# UNITED STATES PATENT AND TRADEMARK OFFICE

10/817,405

## Office Action Summary

## DETAILED ACTION

FIG. 1

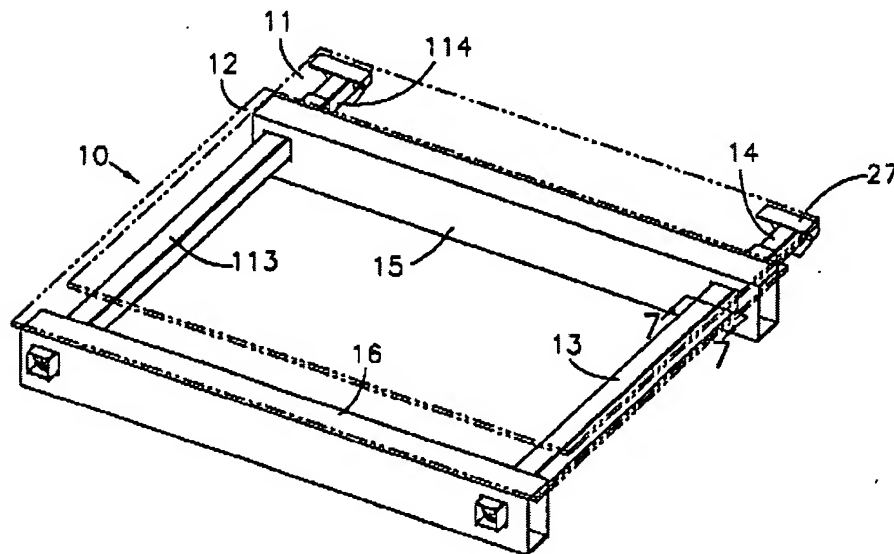
- a. "A moveable wall comprising: a panel..." ("sliding floor" 11, Fig. 1).
  - b. "...a first bracket connected to a first side of said panel..." ("nut flange" 23 and "nut" 22 combined, Fig. 4).

FIG. 4

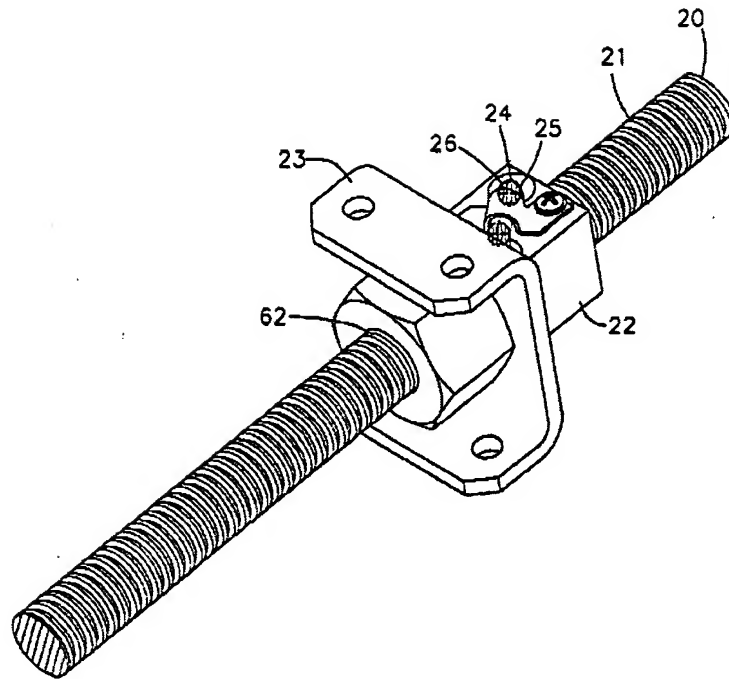
- c. "...a second bracket connected to a second side of said panel..." ("nut flange" 23 and "nut" 22 combined, Fig. 4; Fig. 6 shows an embodiment with two identical drive screws mated by a drive shaft, each drive screw having the same components).

- a. "a top plate..." ("top plate," examiner amended Fig. 4).
  - b. "...two side plates, said side plates supporting said top plate..." ("side plates," examiner amended Fig. 4).

- a. "...a ball screw, said ball screw engaging said first and second screws."  
("nut" 22 with "balls" 24, Fig. 4).

FIG. 6

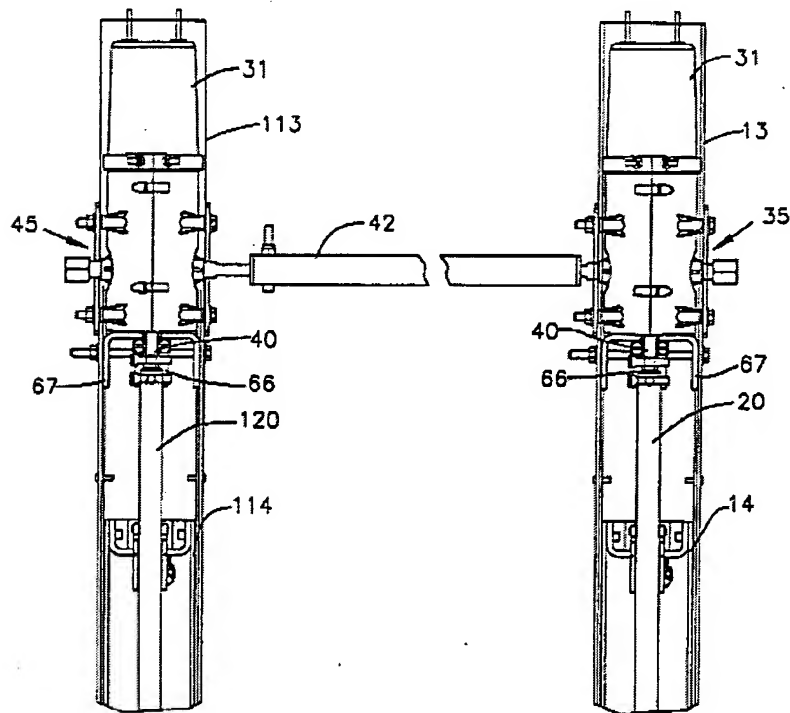
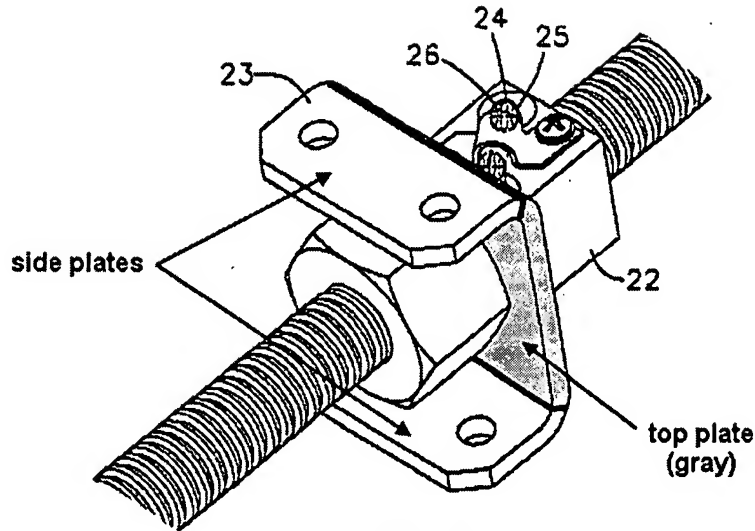
- d. "...a first screw...located on the first side of said panel and engaging said first bracket..." ("drive screw" 20, Fig. 6).
  - e. "...a second screw...located on the second side of said panel and engaging said second bracket ..." ("drive screw" 120, Fig. 6).

- f. "...a motor..." ("motor" 31, Fig. 6).

- g. "...a shaft rotatable by said motor..." ("cross shaft" 42, Fig. 6).
- h. "...a first gearbox being connected to said shaft...further being connected to said first screw..." ("gearbox" 35, Fig. 6).
- i. "...a second gearbox being connected to said shaft...further being connected to said second screw ..." ("gearbox" 45, Fig. 6).
- j. "...wherein rotation of said shaft rotates said first screw and said second screw at an equal rate of rotation." ("The second gear can, in certain preferred embodiments, connect the gearbox via a cross shaft to a second gearbox which is in turn attached to a second drive screw. The second drive screw drives a second ram attachable to the sliding floor. In this manner operation of the motor or motors drives both rams substantially simultaneously," column 2, lines 27-33).
